Planning Commission Regular Meeting

Wednesday, December 06, 2023 at 6:30 PM

- [A.](#) Staff Report 23-060, Request for Conditional Use Permit CUP 23-08 for a Planned Unit Development at 1563 Homer Spit Road, 1663 Homer Spit Road, and 1491 Bay Avenue.

LIGHTHOUSE VILLAGE DEVELOPMENT
 DOYON, LIMITED
 1563 & 1663 HOMER SPIT ROAD, HOMER, AK
 SITE PLAN

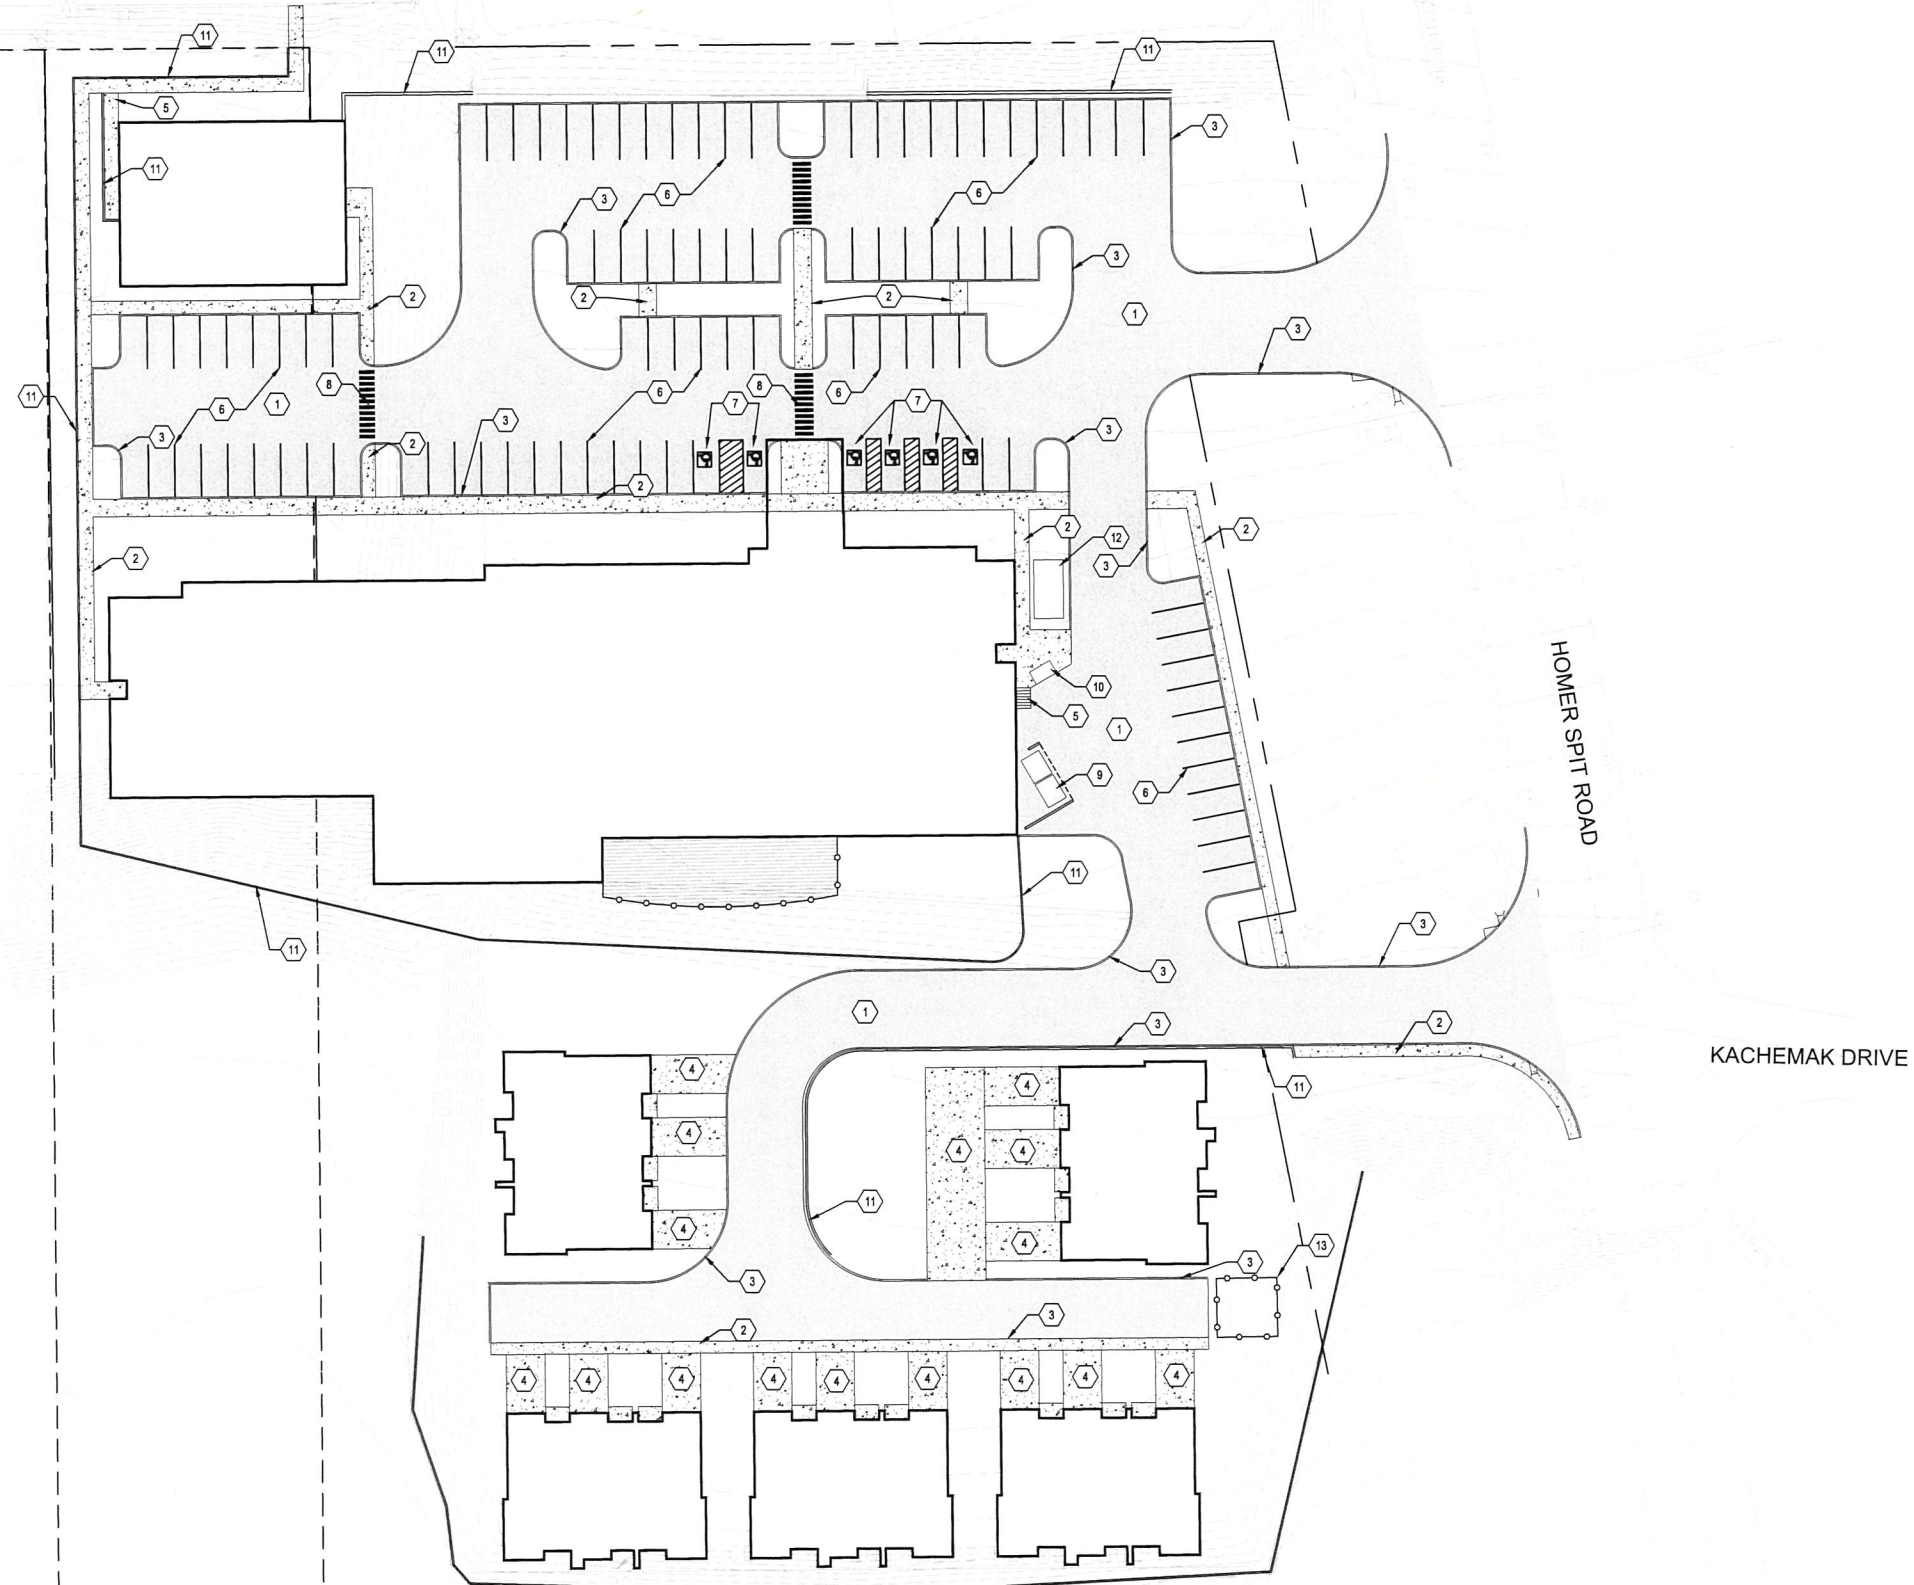
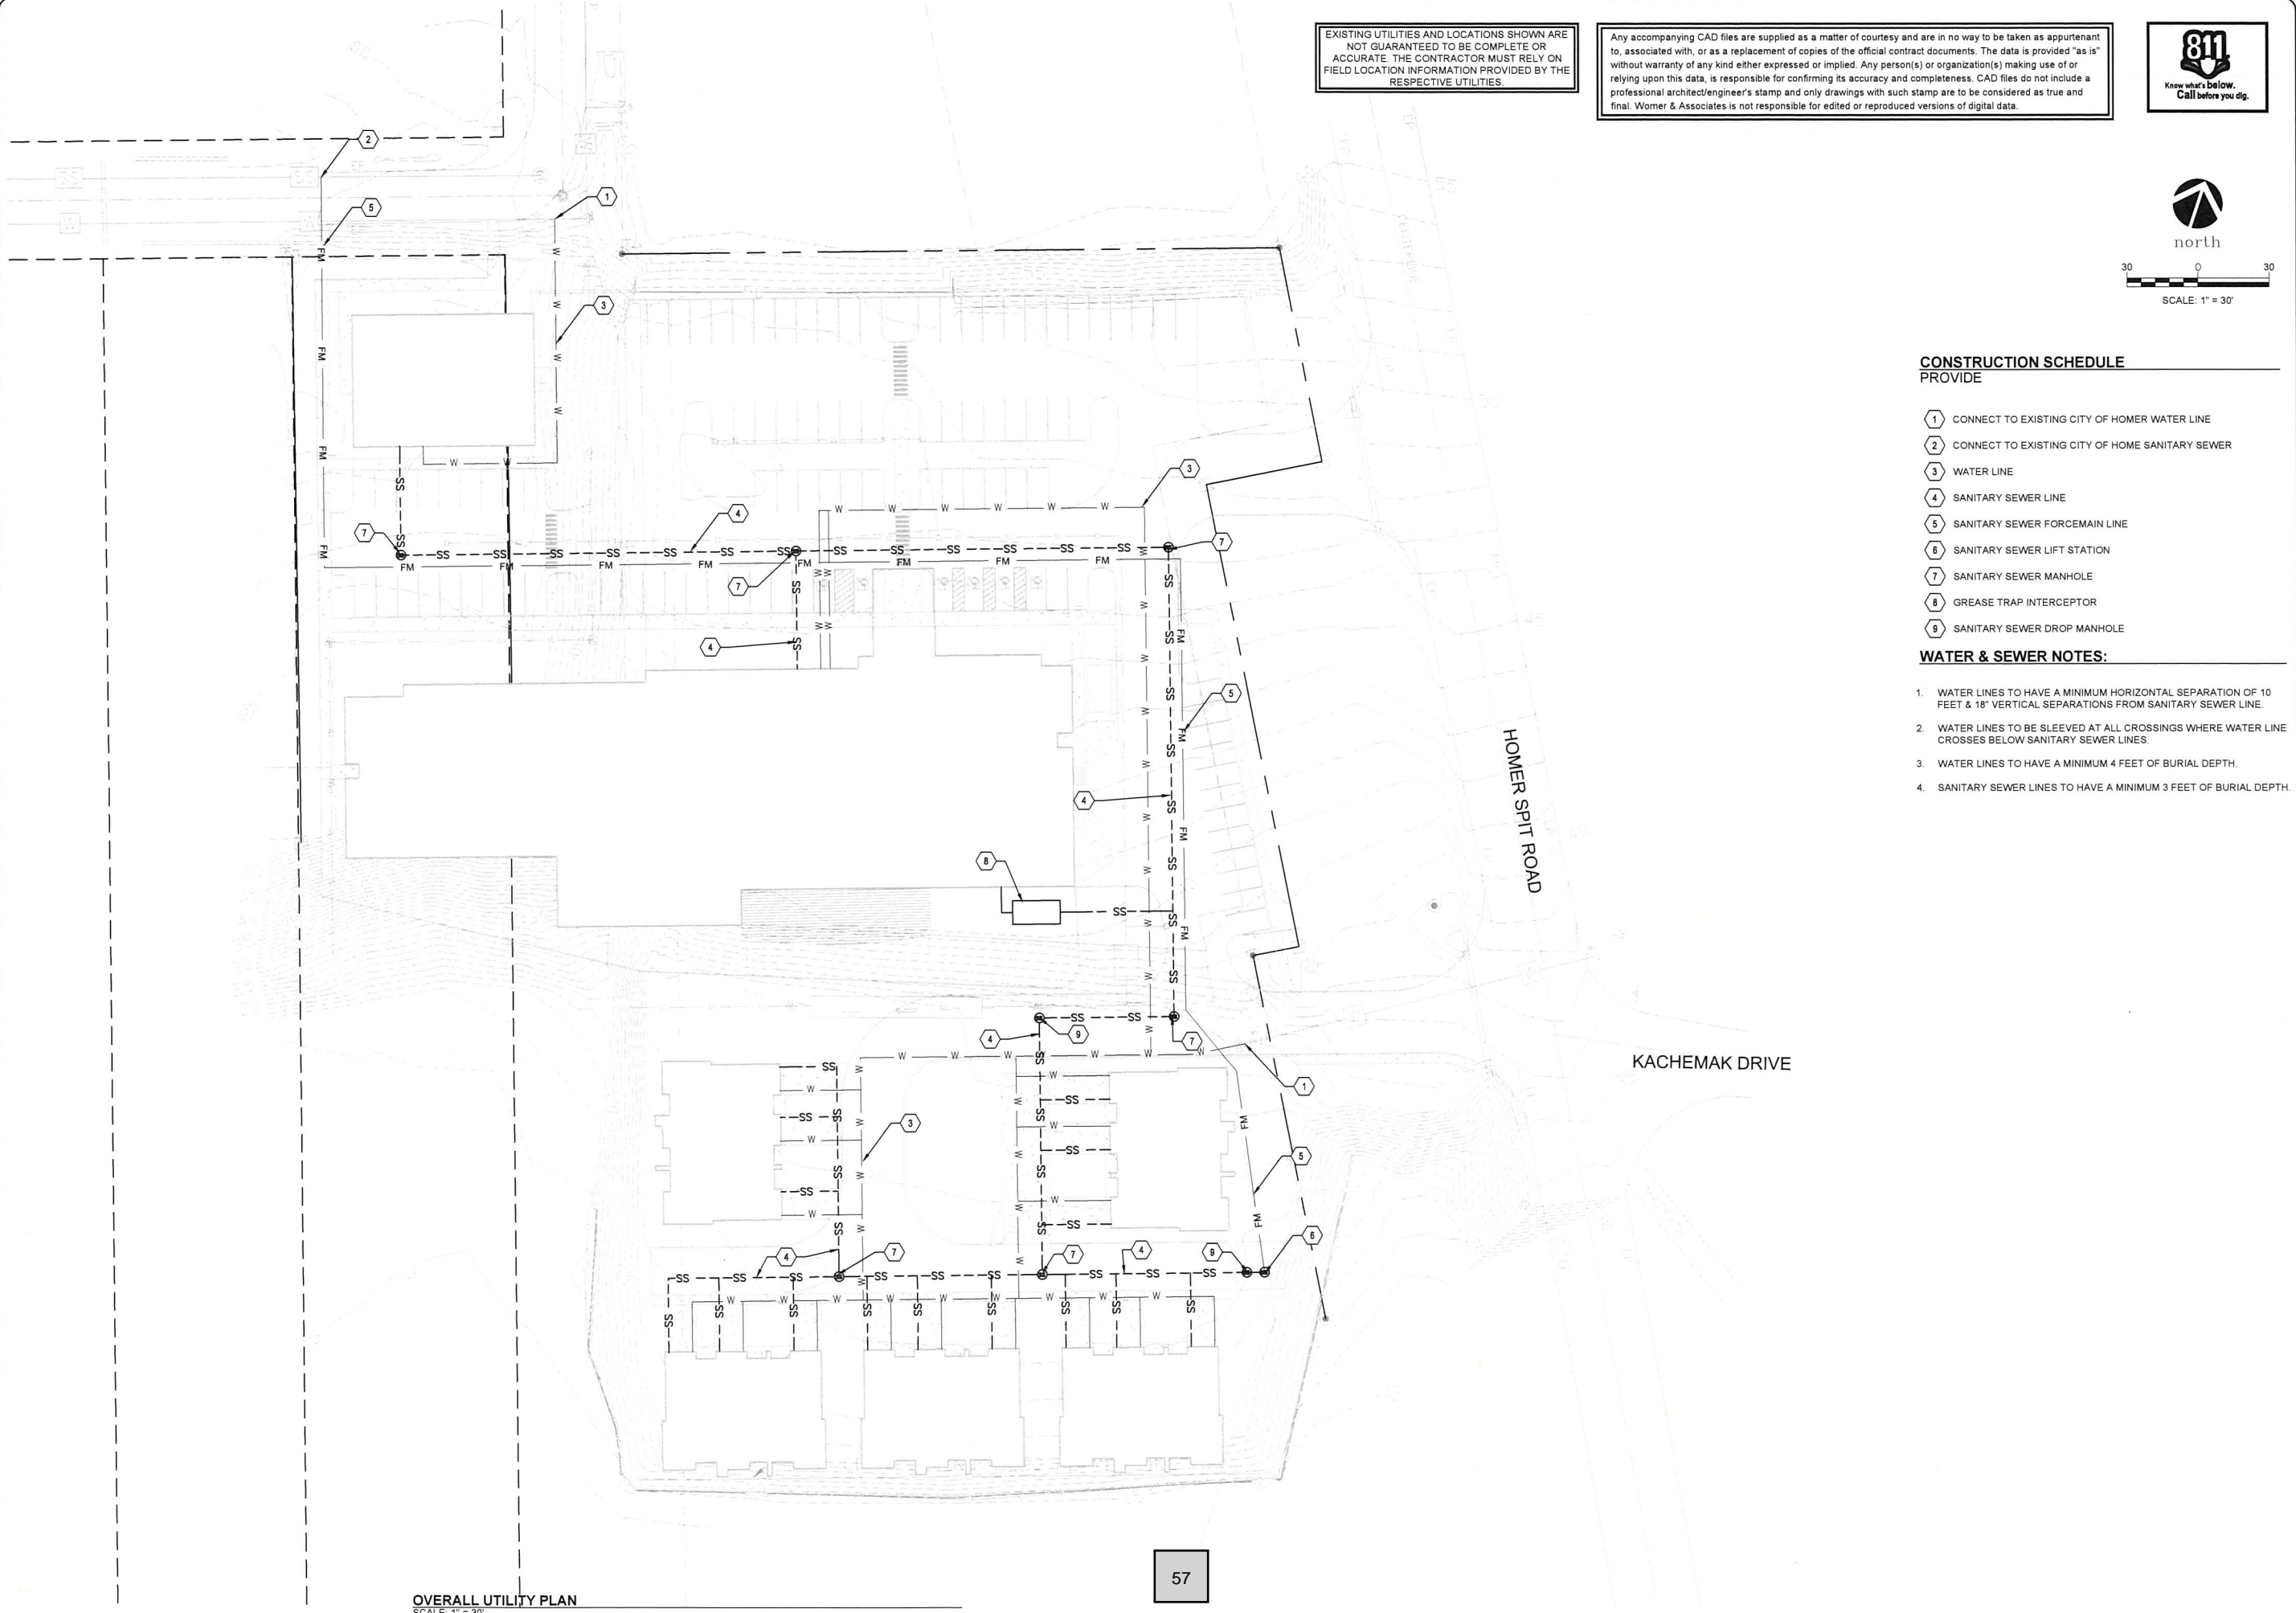
- e. Sheet C4.00 does not show cross walks across the "Spit Road".
 - Recommendation: Show cross walks, with Rapid Flashing Beacons, across the "Spit Road".

- f. Sheet C4.00 does not show traffic signs or other permanent traffic control devices.
 - Recommendation: Provide a permanent traffic control plan
- g. Sheet G0.00 refers the "infamous Homer Spit".

STORMWATER PLAN
 SCALE: 1" = 30'

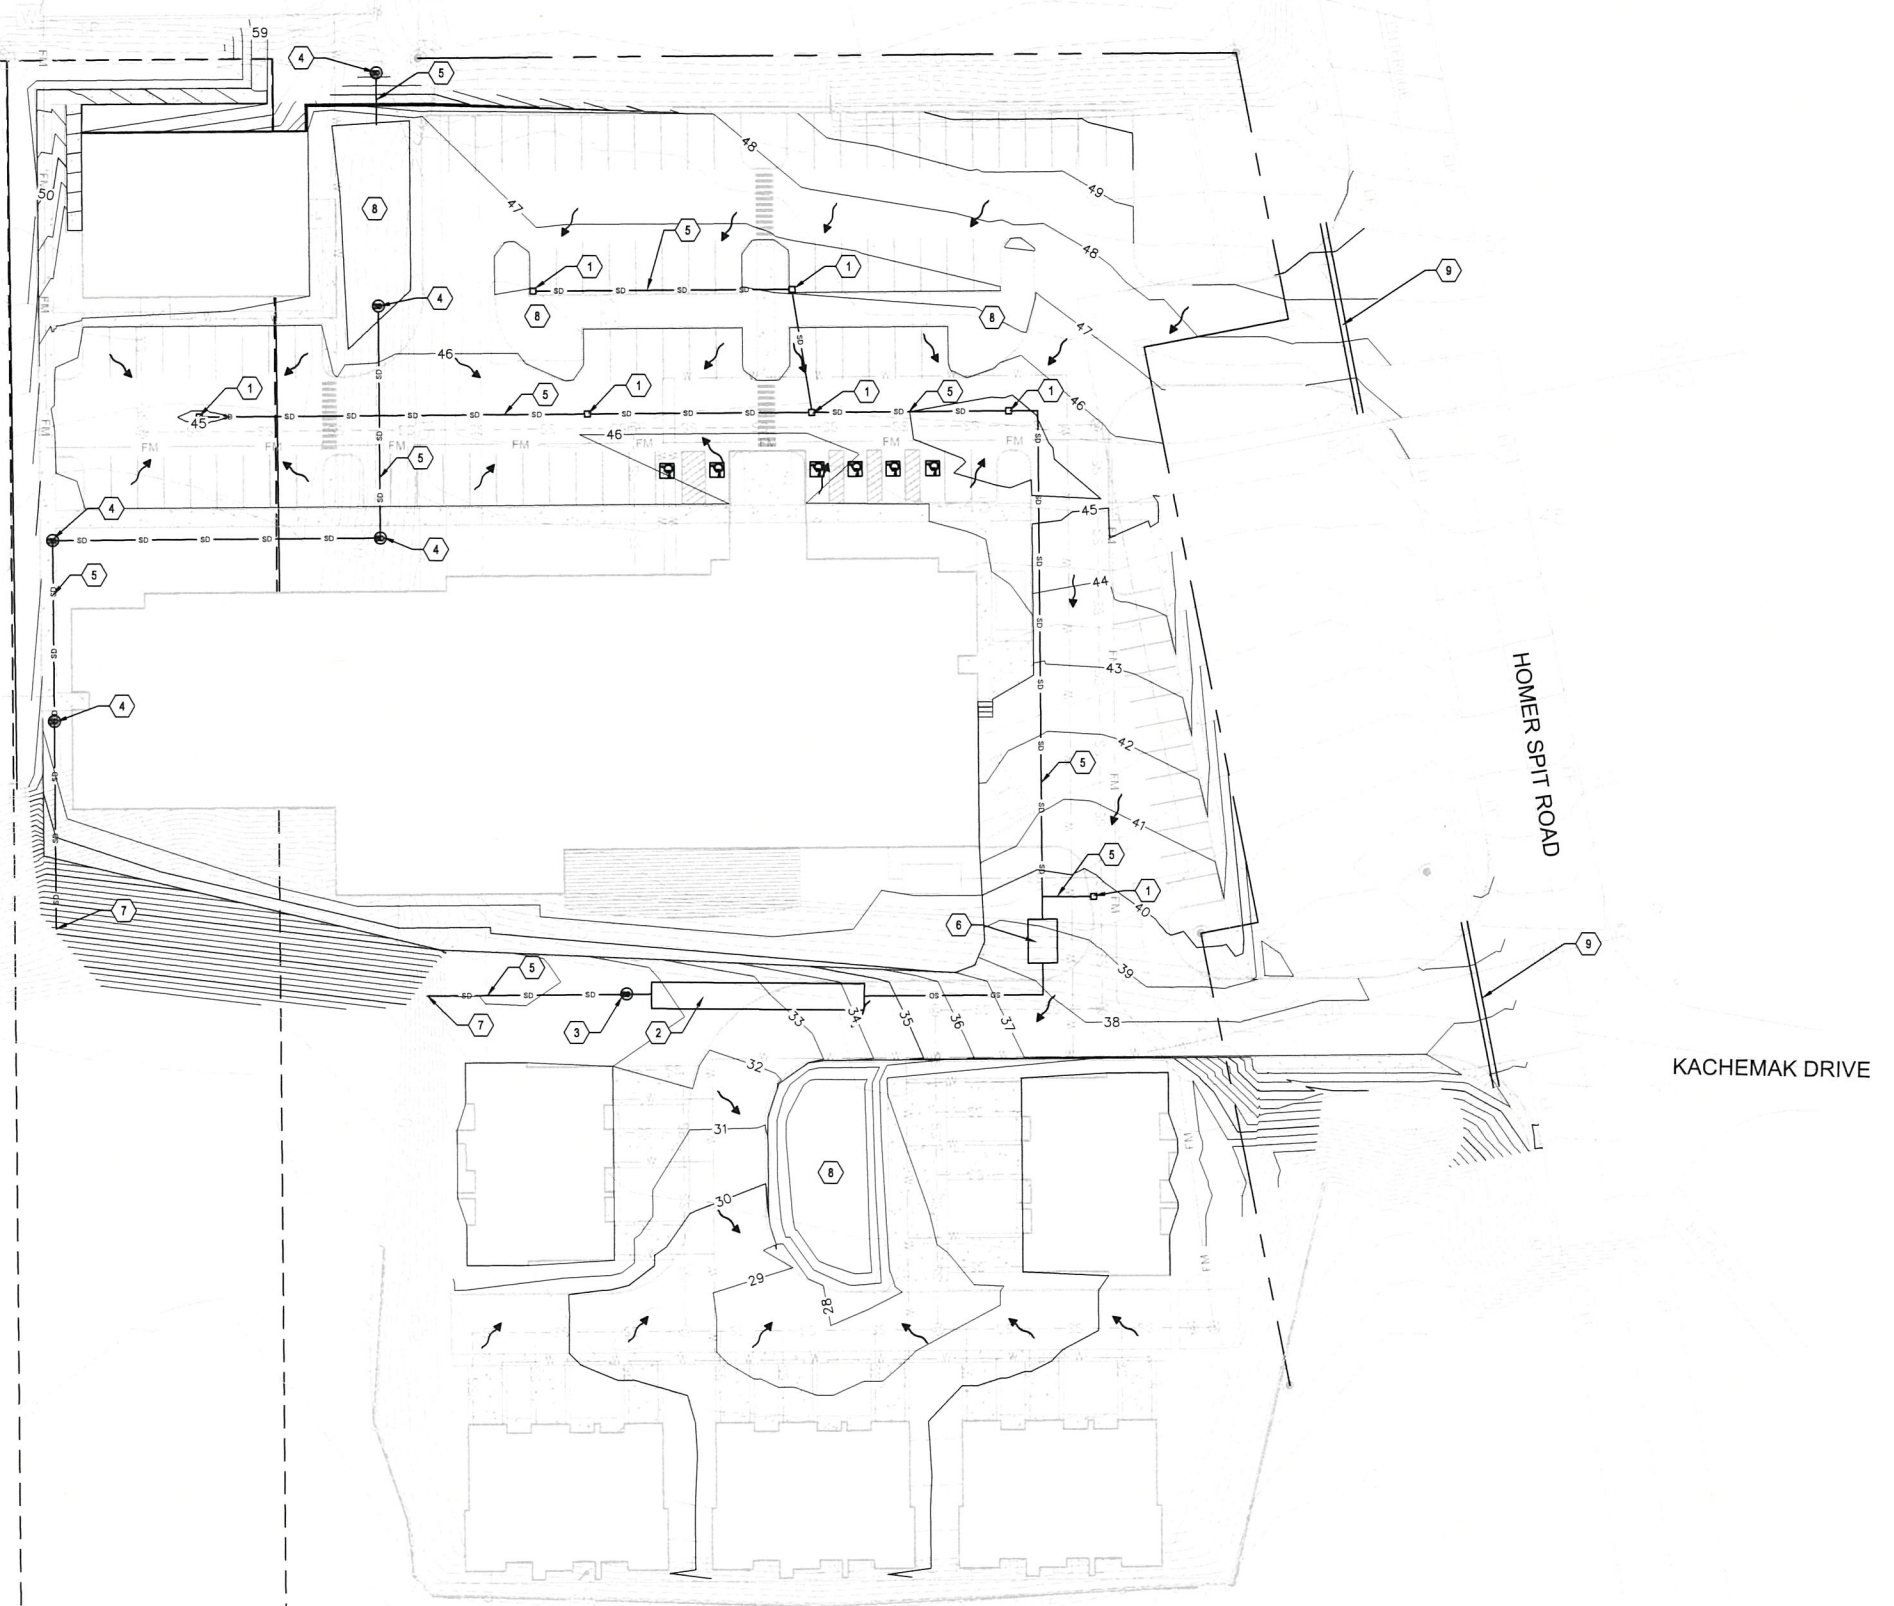
- Recommendations:
 1. Show the existing wooden viewing platform and indicate that it will be demolished.
- d. Sheets C2.00, U2.00 and AS0.01 do not show details of the culverts, swales, rain gardens or other green infrastructure features.
